PREAMBLE AT HANNAH RIDGE
FILING NO. 3
STREET IMPROVEMENT PLANS
NIGHTWIND HEIGHTS, EQUINE CT./CUL-DE-SAC

PUBLIC EXTENDED DETENTION BASIN GRADING AND OUTLET PROFILE POND 1

V1_Construction Drawings (Plans-Profiles).pdf Markup Summary

EQUINE COURT
(PUBLIC 50' ROW) DESIGN SPEED - 25mph URBAN LOCAL - LOW VOLUME

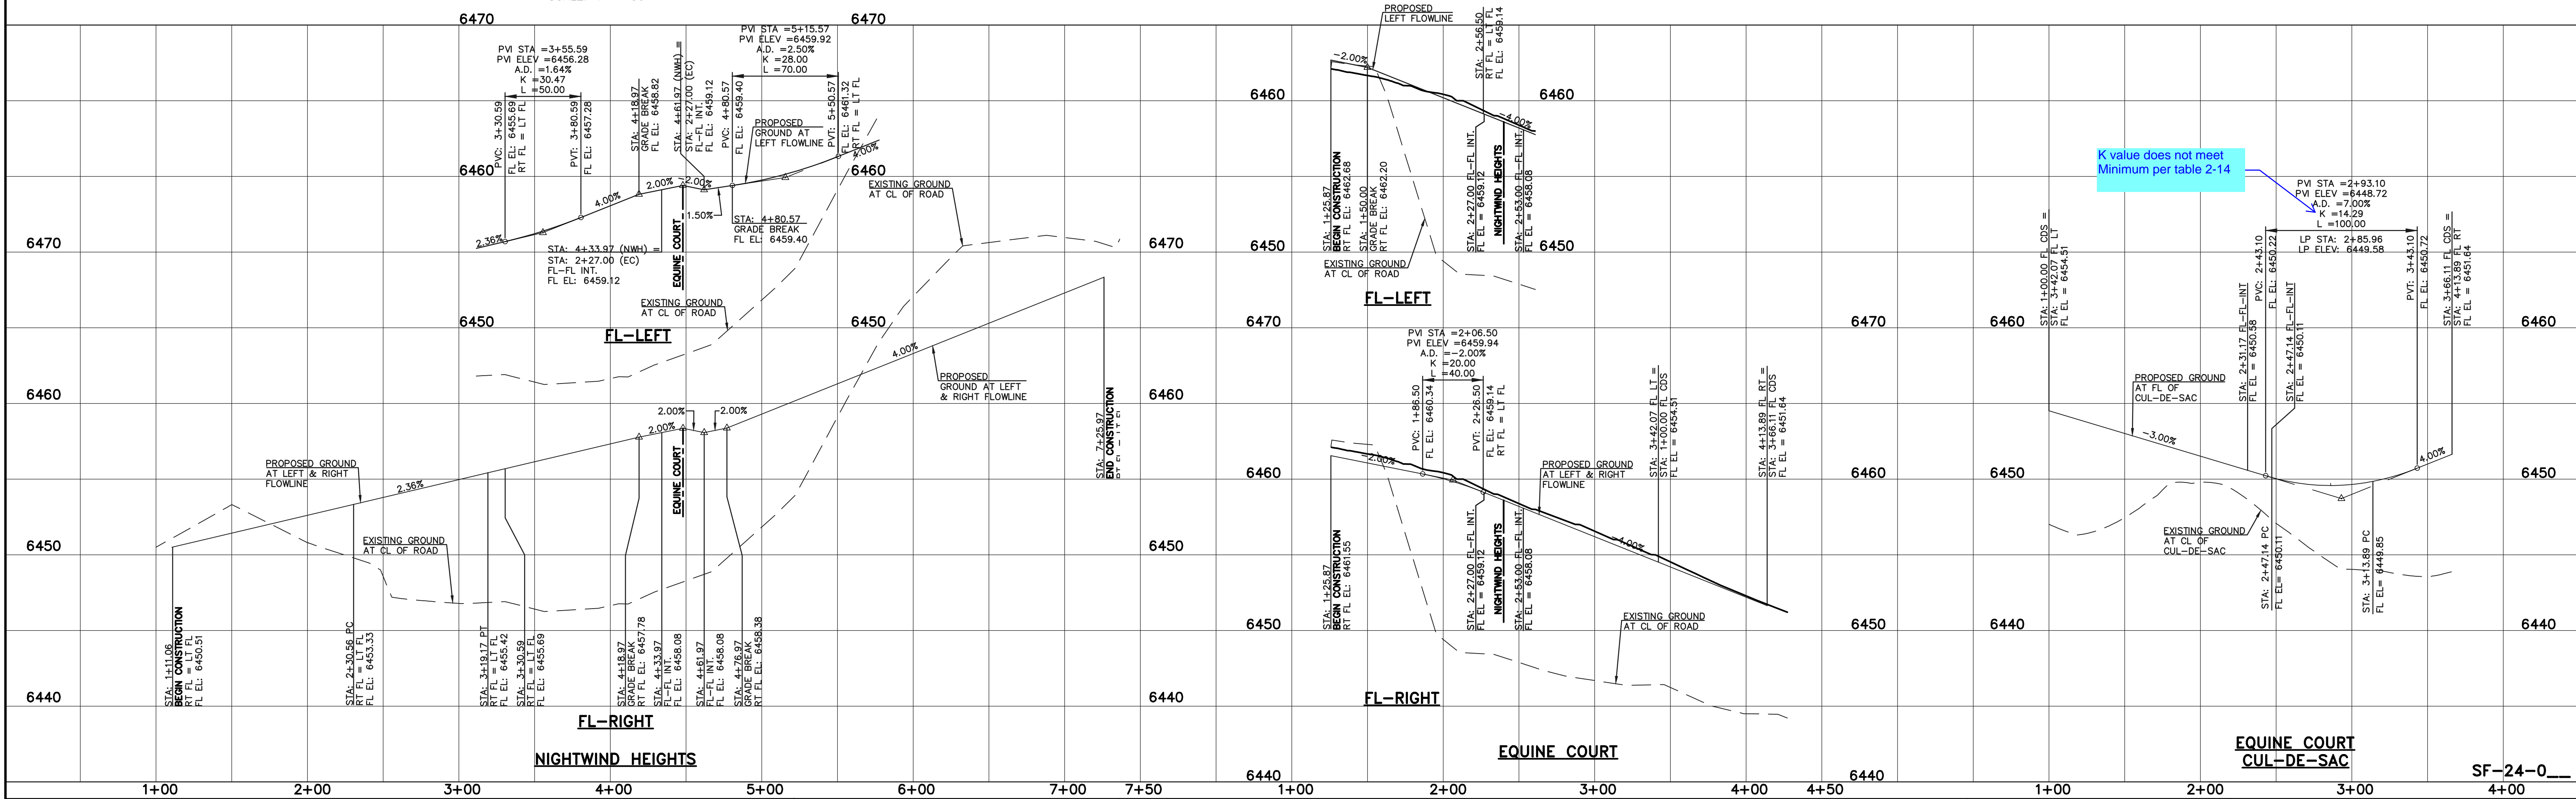
K value does not meet
Minimum per table 2-14

PRIVATE STORM SEWER RUN 1 & RUN 1 LATERAL 1

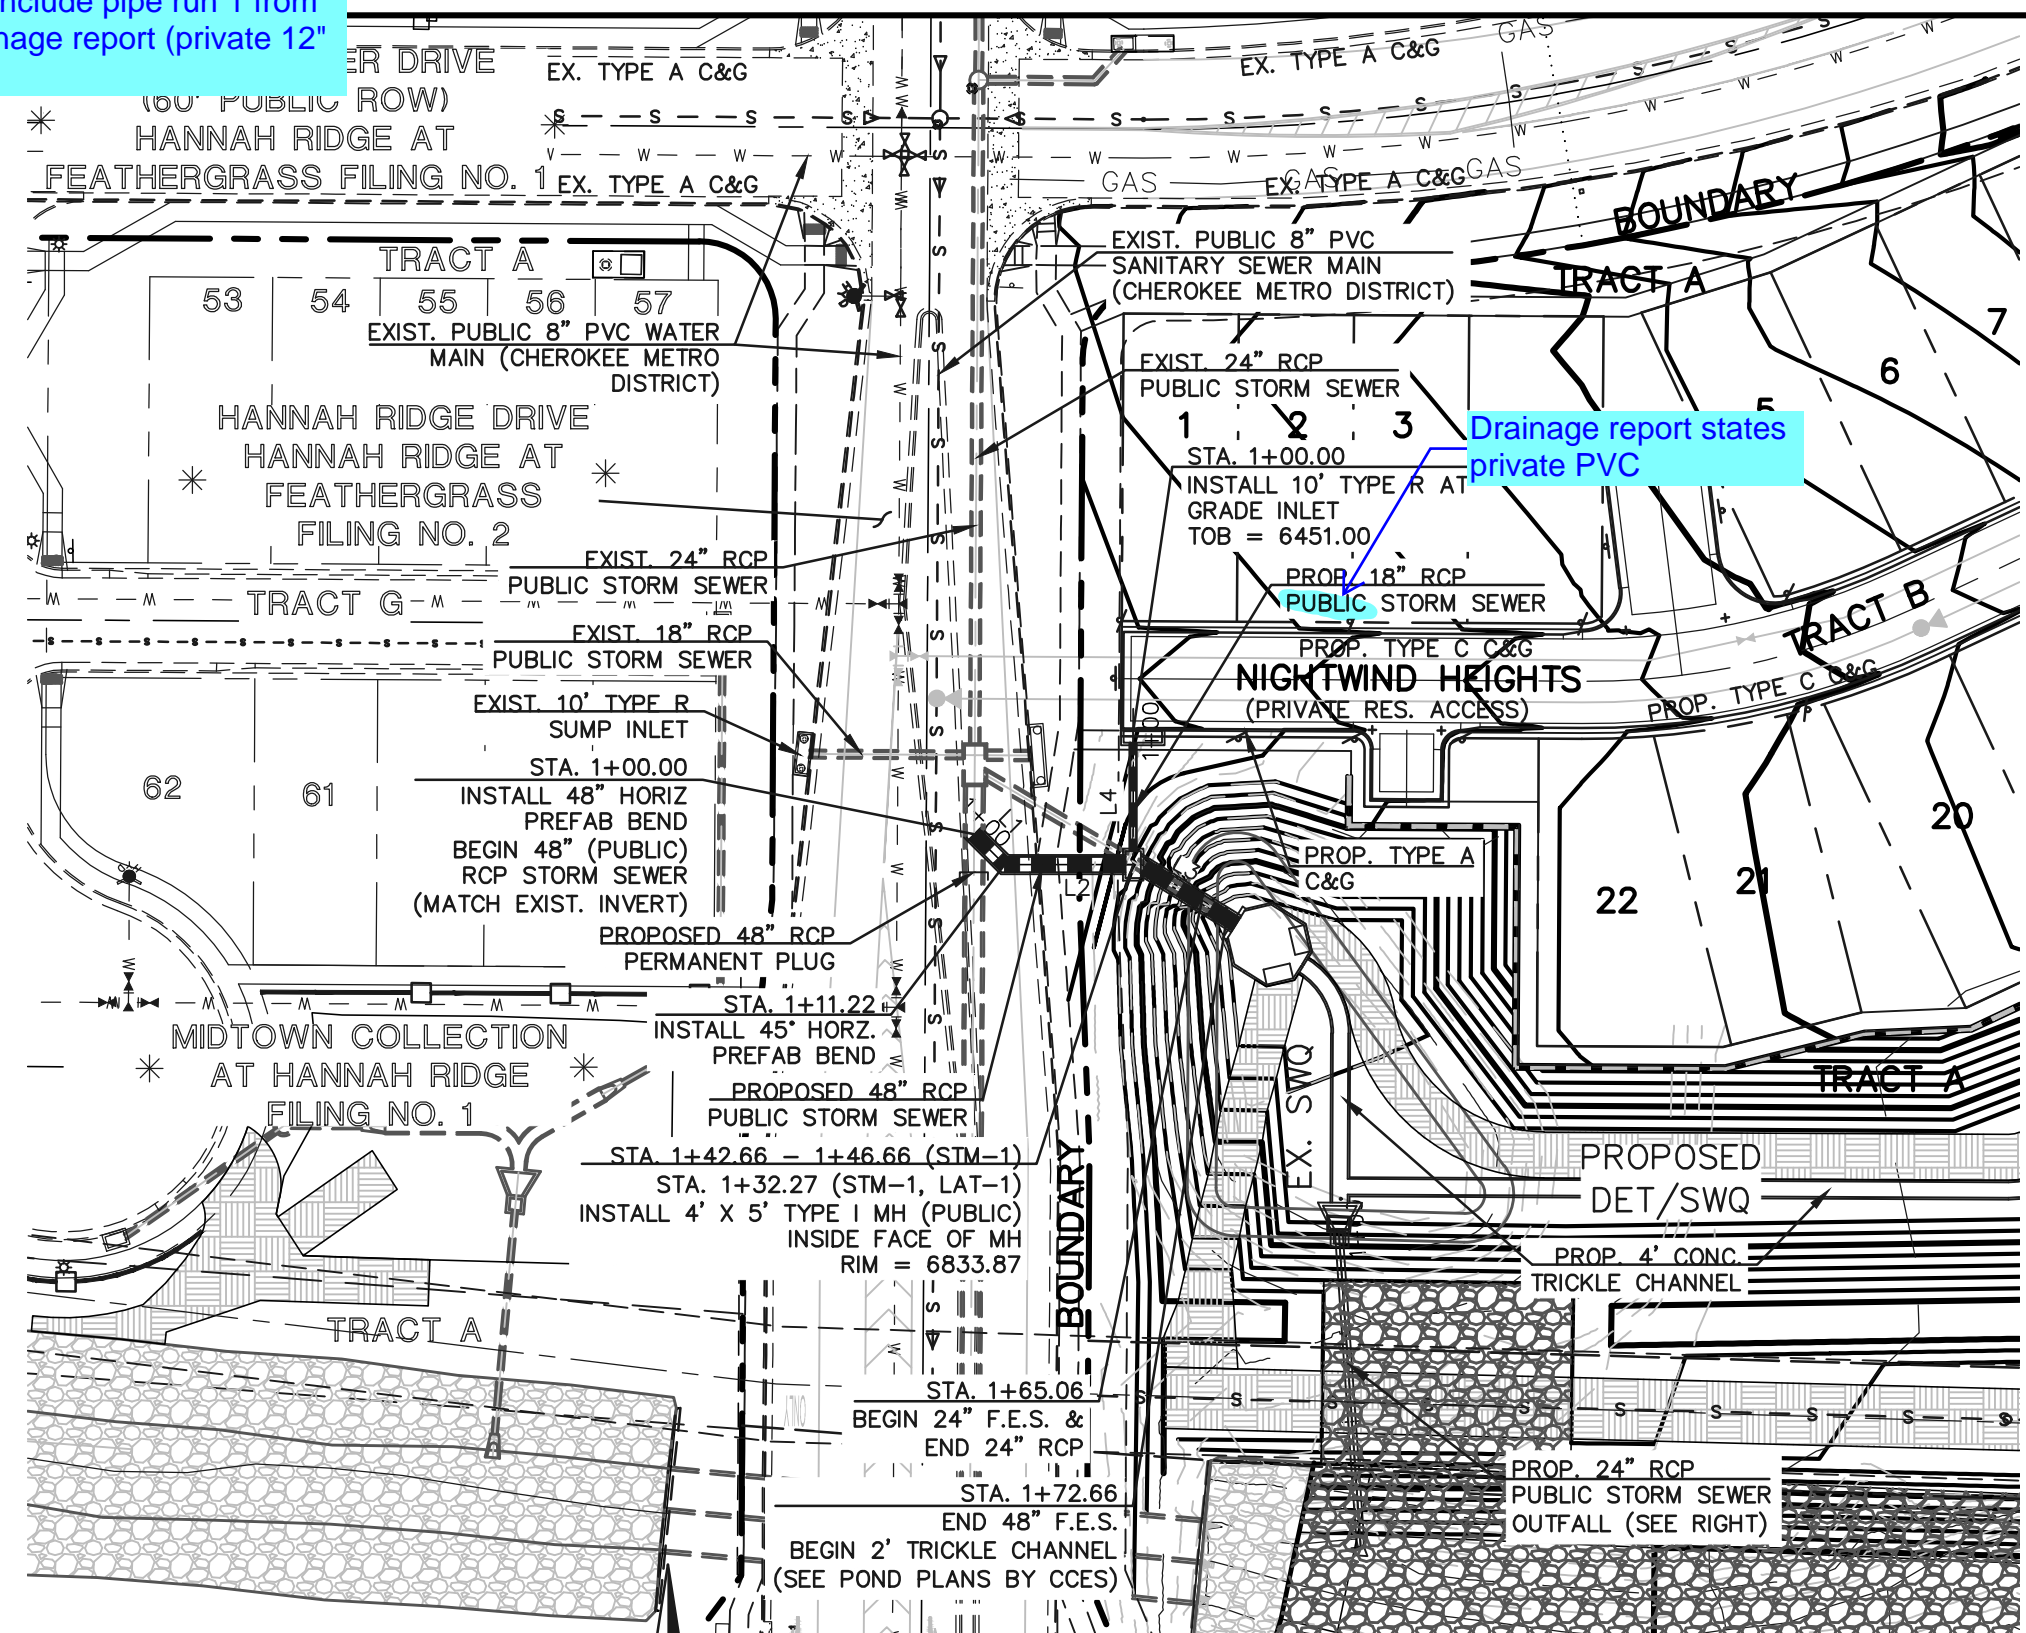
Please include pipe run 1 from the drainage report (private 12" PVC)

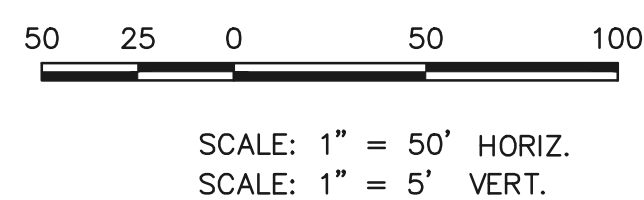
Drainage Report indicates public

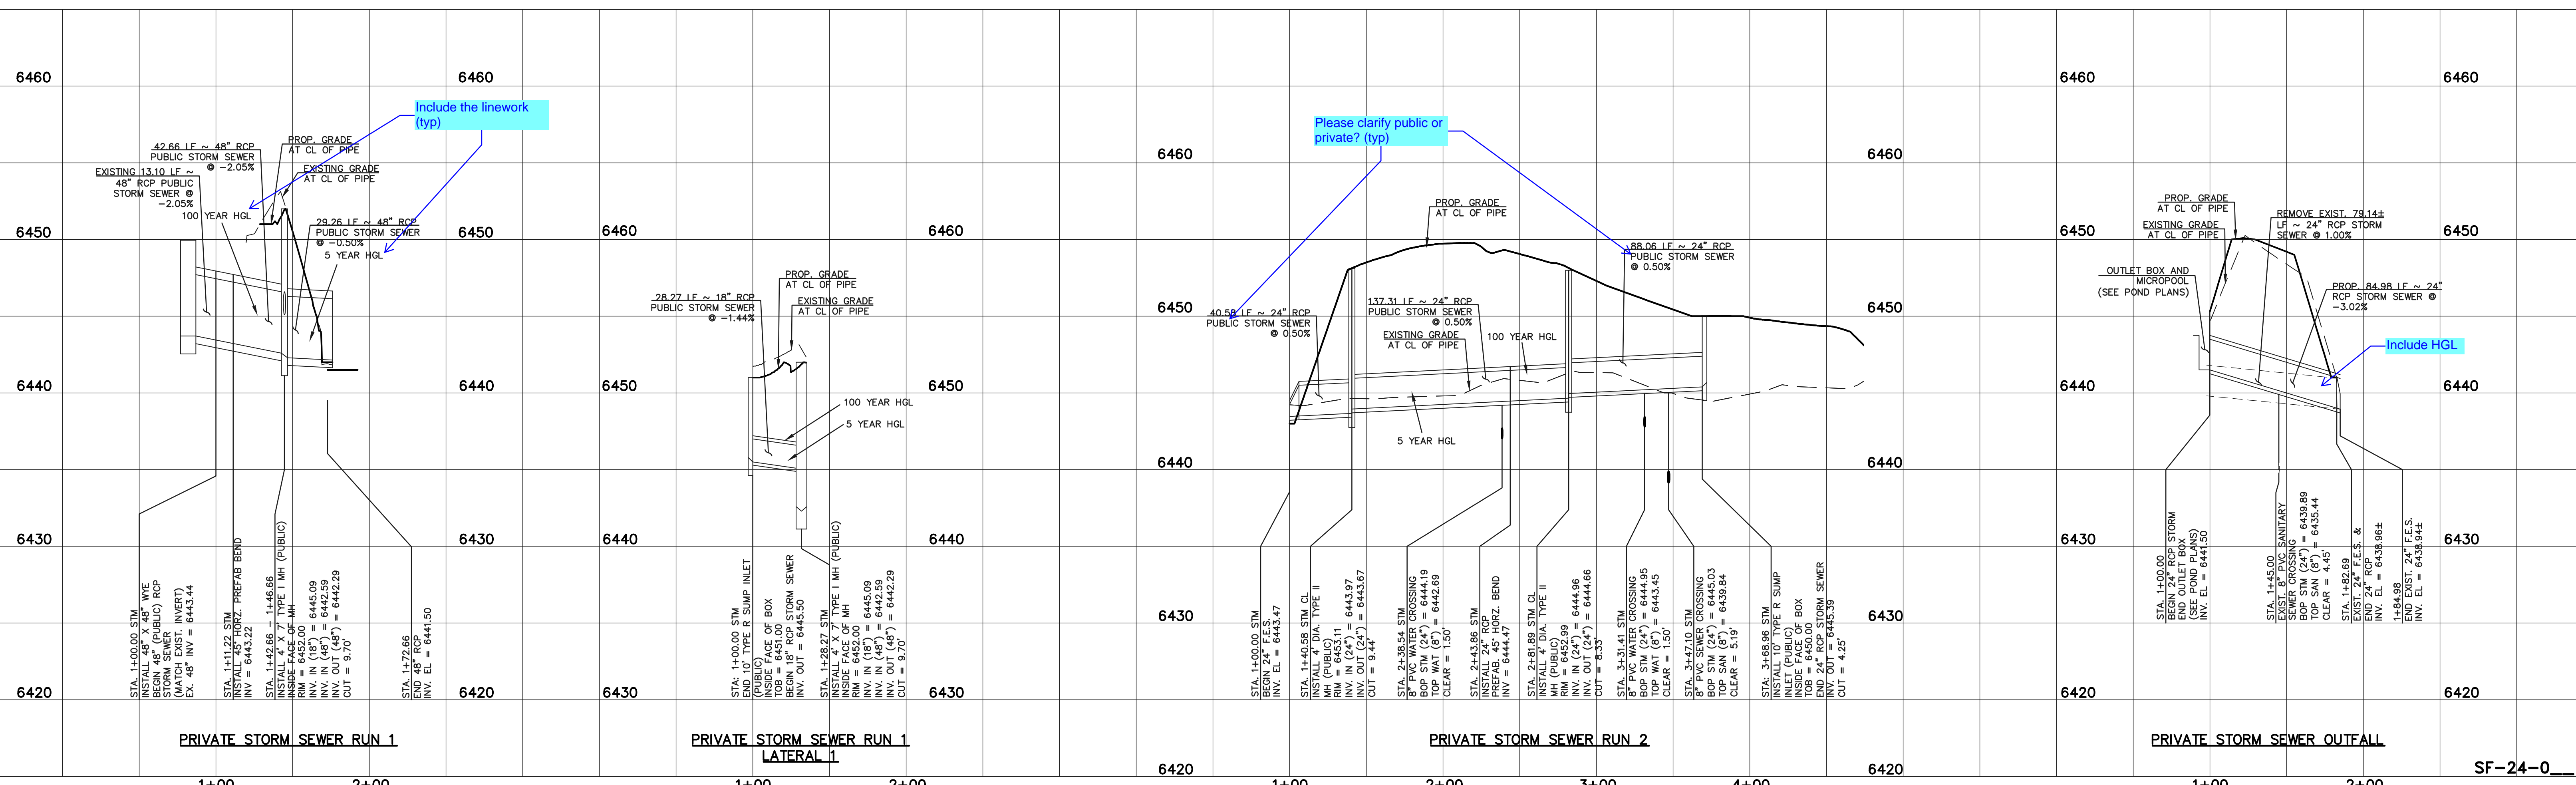
Include the linework (typ)

Please clarify public or private? (typ)

Include HGL

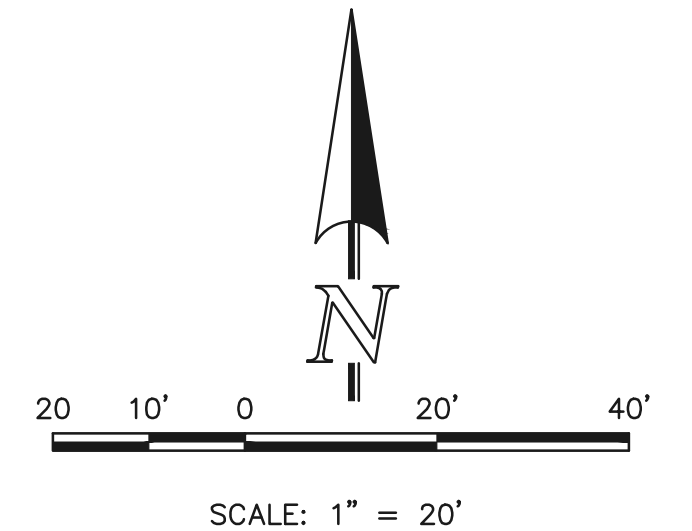
Stabilized access ramp shall be a minimum of 15ft wide and no greater than 12% slope, in accordance with DCMv1, Chap 11.2.2.
